RE: Northern Natural Gas
Northern Lights 2025 Expansion
Docket No. CP24-60-000
Variance Request – Extra Temporary Workspace – Lake Mills to Albert Lea E-line Extension

Northern Natural Gas Company
Northern Lights 2025 Expansion

NORTHERN LIGHTS 2025 EXPANSION PROJECT
LAKE MILLS TO ALBERT LEA E-LINE EXTENSION
ALIGNMENT SHEET
SEC. 4, T101N, R22W
FREEBORN COUNTY, MINNESOTA

PROJECT NO.
01146980
DWG. NO.
LML P3-6

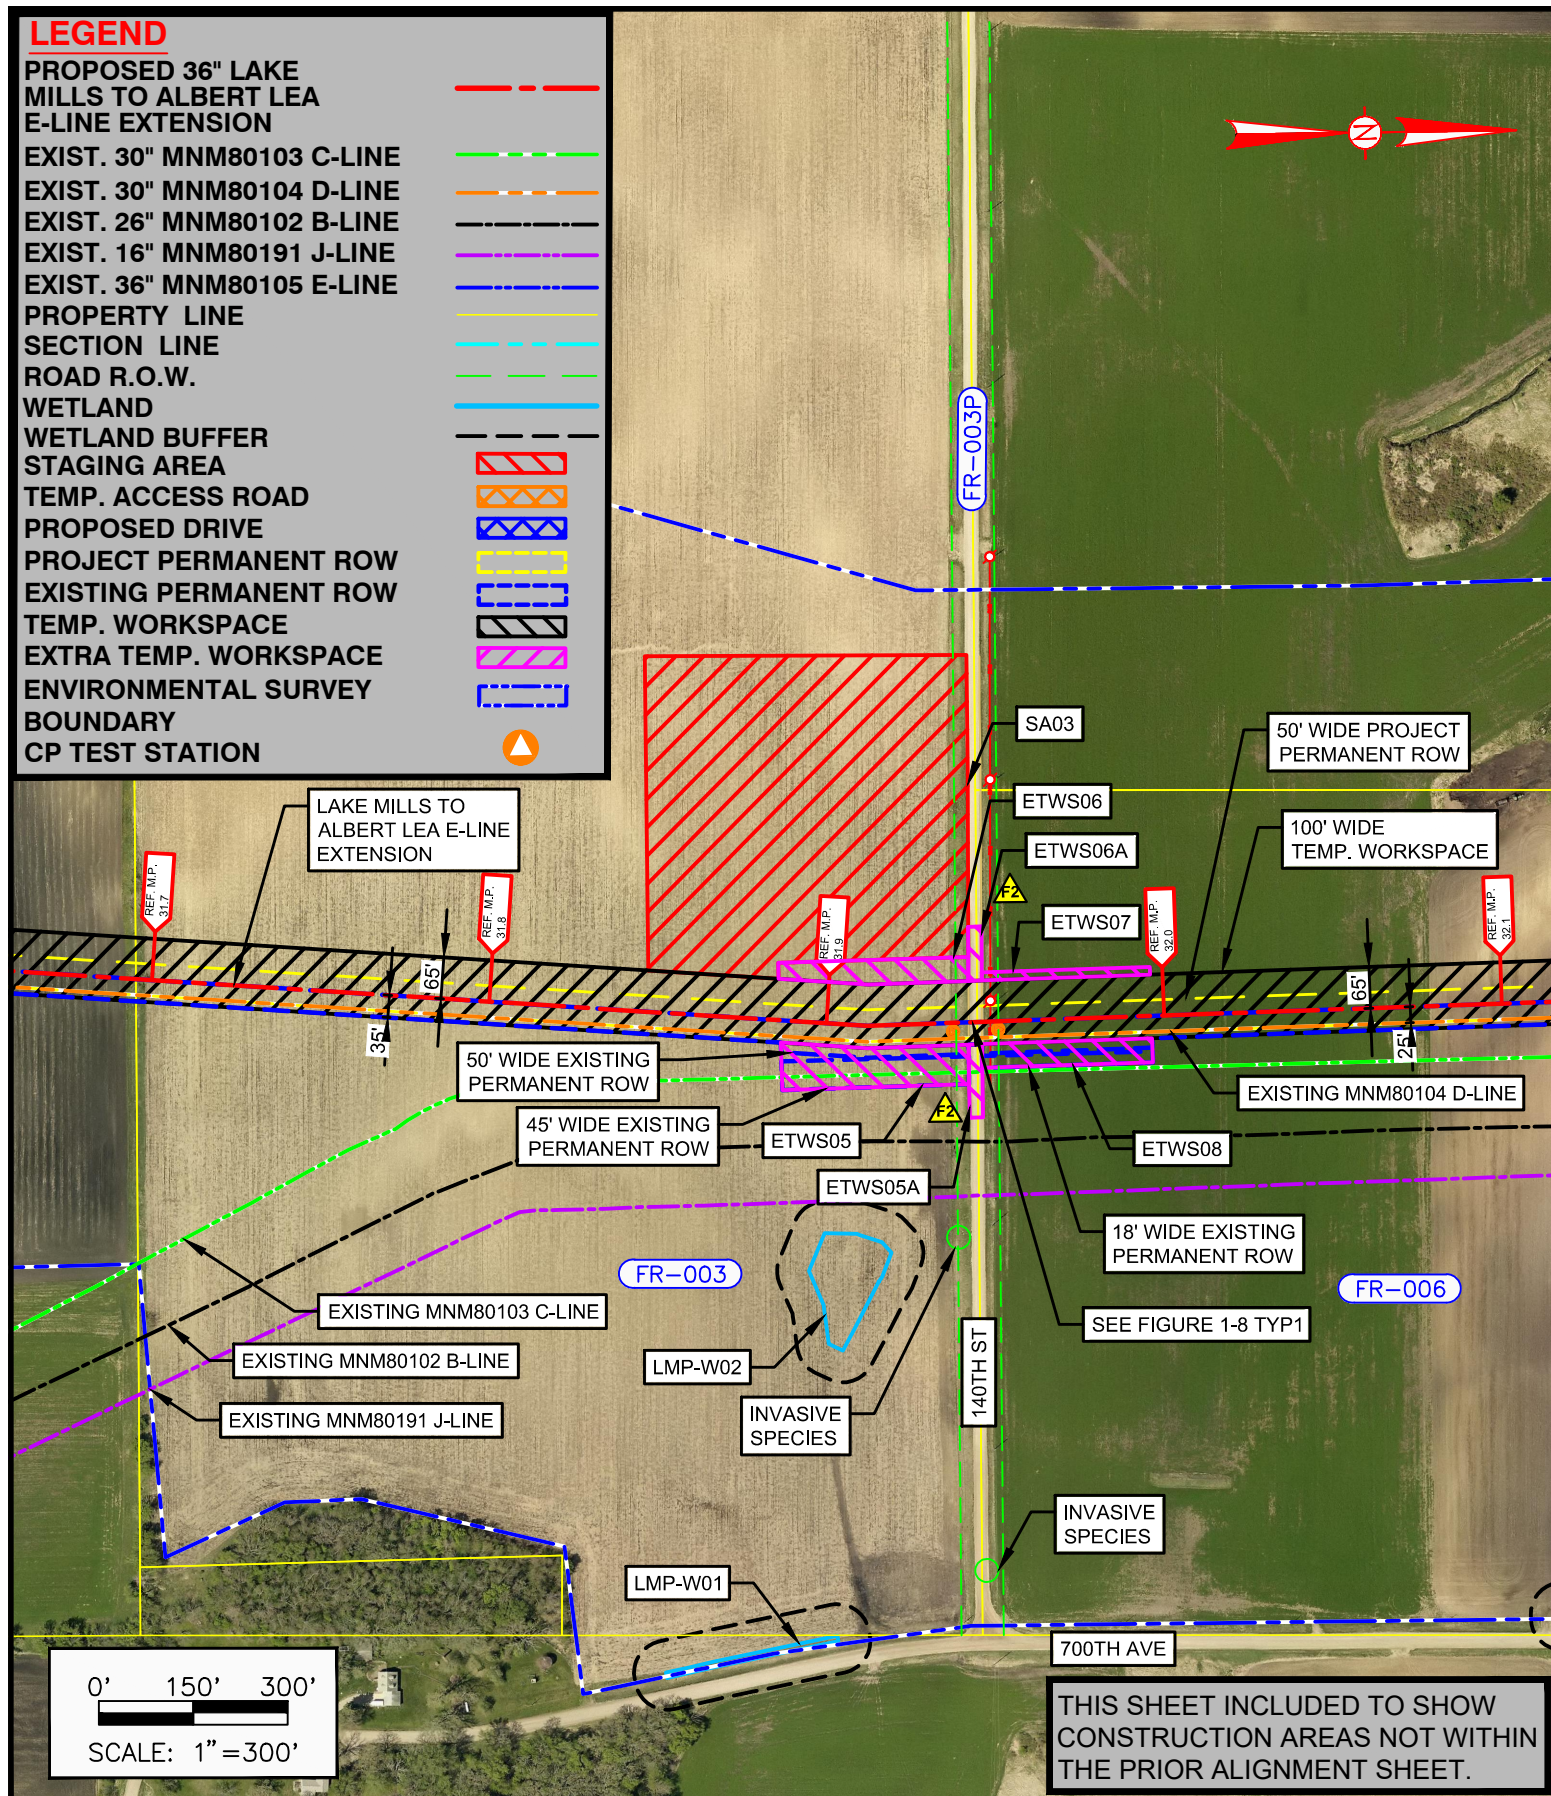
Specifically, Northern is requesting approval to use additional ETWS on either side of the open cut crossings of 140th Street (MP 31.95, alignment sheet LML P3-3) and County Road 80¹ (MP 33.19, alignment sheet LML P3-6) for the Lake Mills extension. The additional ETWS is needed to accommodate an 8:1 slope requirement Freeborn County and Nunda Township, respectively, have included in their permits for the open cut crossings. The additional workspace is required to excavate the roadways to an 8:1 slope out from the pipeline trench requiring a much wider trench than originally proposed. The shallower slope will allow better re-compaction of the roadways upon backfill.

The attached alignment sheets depict the four proposed ETWS, which are highlighted with a Delta F2 symbol. At 140th Street, ETWS06A measures 85 feet by 20 feet (0.04 acre) and ETWS05A measures 115 feet by 20 feet (0.05 acre). At County Road 80, ETWS09A measures 85 feet by 25 feet (0.05 acre) and ETWS10A measures 115 feet by 25 feet (0.07 acre). The proposed ETWS will be located entirely within the road right of way with no impact on other landowners. The surrounding area is active farmland. No sensitive

environmental or cultural resources will be impacted; ETWS09A is located within the 50-foot buffer of wetland LMP-W07, which is actively farmed and has therefore been disturbed. The additional workspace is located within the environmentally cleared area and no additional agency consultation is required. On June 27, 2025, Freeborn County and Nunda Township provided written approval for the additional workspace in order to maintain the 8:1 slope requirements.

NO.	REVISION - DESCRIPTION	BY	DATE	CHK'D	APP'D
	ADDED ETWS10A & ETWS09A	MB	6/23/25	ED	GC
F1	RE-ISSUED FOR FERC (NO CHANGE)	JM	1/14/25	ED	GC
F	ISSUED FOR FERC	AC	2/2/24	ED	GC
